CIBAB Study Kick-off meeting

BISv2 Reliability Study Progress Meetings

Failure rate prediction results

Questions

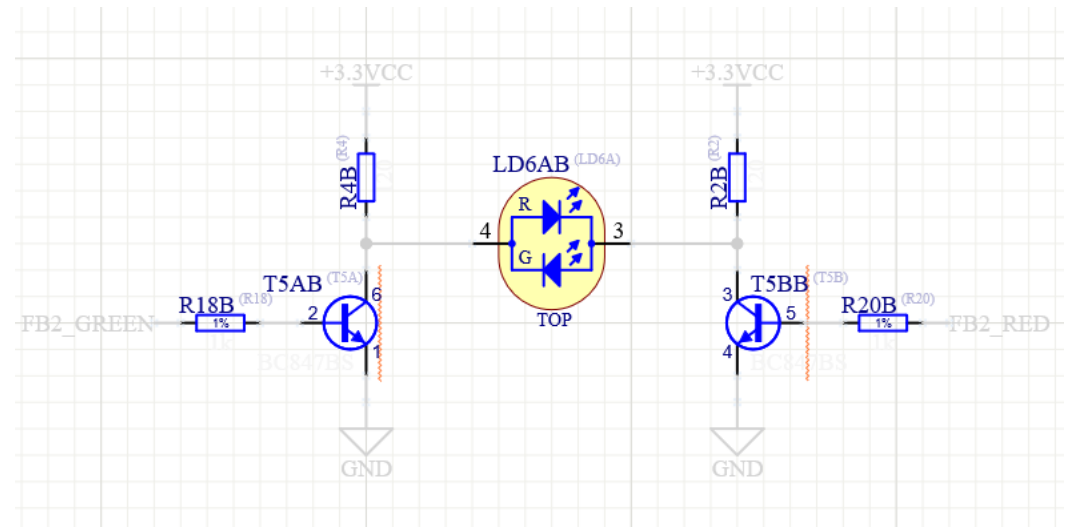
1. Why are there 3 instead of 2 sets of signals on the output?
 - I.e., BEAM_PERMIT_1, BEAM_PERMIT_2, BEAM_PERMIT_3 (OUT_P, OUT_N, FB_P, FB_N).
2. Is there a designator naming convention?
 - See the example below.
 - Letters at the end also used to refer to the same component in multiple places (i.e., FPGA).
3. Can a misconfiguration of enabling/disabling Front Panel or Rear Connectors modes impact operation?
4. Temperatures assumed for failure rate prediction:
 - 25°C non-operating,
 - 35°C operating,
 - 10°C case temp rise (where applicable).
